Access Compliance Report

Public Rights-of-Way

(Curb Ramps)

Intersection ID: N/A	Main Street: YORK_CENTER	Cross Street: N/A	Location: NE
ADA ID: F9903D412123	Ramp Type: Perp	Initial Pass/Fail: Fail	Overall Compliance: No
Codes/Mitigation Info/Possible Solution		Field Measurements/Component Compliance	
Severity Score: 22.5

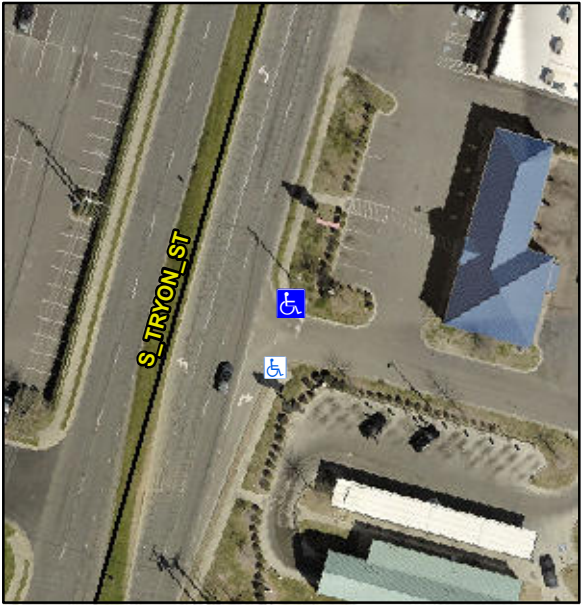
Possible Solutions:				
	Remove & Replace Entire Ramp.				
	Surveyor Notes:				
	N/A				
	PROW/ADA:				
	Not Found, R304.5.1, R304.2.2, R304.5.3				
	Street 1 Name	ENTRANCE	Compliance	Description	Data
	Stop Condition-Street 2	StopSign	No	Ramp Length (in)	91.5
	Street 2 Name	N/A	No	Ramp Width (in)	47.0
	Stop Condition-Street 1	N/A	N/A	Flare Type LT	N/A
			N/A	Flare Slope LT (%)	N/A
			N/A	Flare Traversable LT?	N/A
			N/A	Landing Length (in)	N/A
			N/A	Landing Width (in)	N/A
			N/A	Landing Slope (%)	N/A
			N/A	Landing X Slope (%)	N/A
			N/A	Landing Curb? (Y/N)	N/A
			N/A	Shared Landing?	N/A
			N/A	Gutter Ponding?	N/A
			N/A	Gutter Lip Ht (in)	N/A
			N/A	Painted X Walk1?	Yes
			N/A	X Walk 1 Direction	To S
			N/A	X Walk 1 Width (in)	54.0
			N/A	X Walk 1 Slope (%)	0.9
			N/A	X Walk 1 X Slope (%)	0.1
			N/A	Ramp inside XWalk1?	Yes
			N/A	Road Slope (%)	N/A
			N/A	Road X Slope (%)	N/A
			N/A	Any Obstructions?	N/A
			N/A	Obstruction Type	N/A

N/A	Clear Space?	N/A
			N/A	Clear Space to XWalk (in)	N/A
			N/A	Storm Grate/Utility Hazard?	N/A
			N/A	Storm Grate/Utility Type	N/A
			N/A	Surface Condition? (G/P)	Good
Total Cost:		\$	1850.00
